## TECHNICAL SERVICE BULLETIN

### **TSB C-GN-SP-0049 REV3**

**Date:** October 22, 2024  
**To:** All Service, Parts Managers, Sales, Distribution, and Sales Representatives  
**From:** Technical Services Department  
**Subject:** **REVISION: Daikin FIT, Amana® Brand S-series, and Goodman SD Software Update**

**This is a revision to the previously distributed TSB C-GN-SP-0049 REV2 on July 3, 2024. This revision updates the instructions for dealer uninstalled inventory. This revision also updates the instructions and warranty code for field installed units to 8827 for labor of \$150.00 per unit and only applies to field installed units not connected to Wi-Fi or installed with an EWC zoning panel.**

### Step 1:

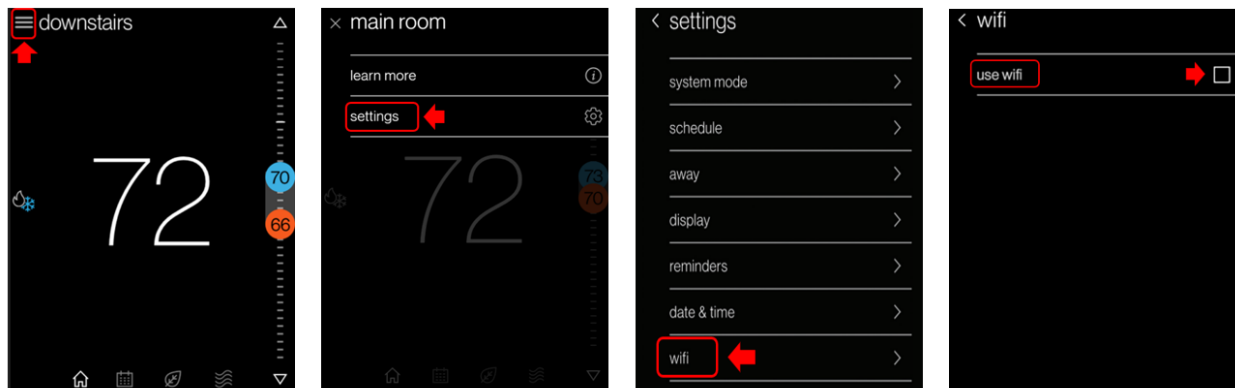
For all Daikin, Amana & Goodman brands replace the outdoor service printed circuit board (PCB) see **Table 3** to verify correct outdoor service replacement PCB part number was sent. If incorrect outdoor service replacement PCB was sent, please order correct outdoor service replacement PCB as per **Table 3**. If the homeowner has a **Goodman GTST connected thermostat (GTST-CW-WH-A)** Step 2 is not required to be completed.
